Pilot piston and pusher DLC

Fits: All DLC slewing valves **Consumption:** 2 kits per valve

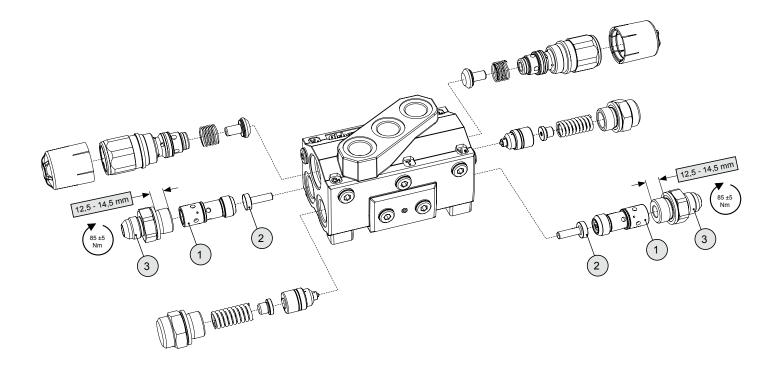
Old pilot piston and pusher are replaced by new models to enable use of different adapters 1 with adapter depth from 12,5 to 14,5 mm.
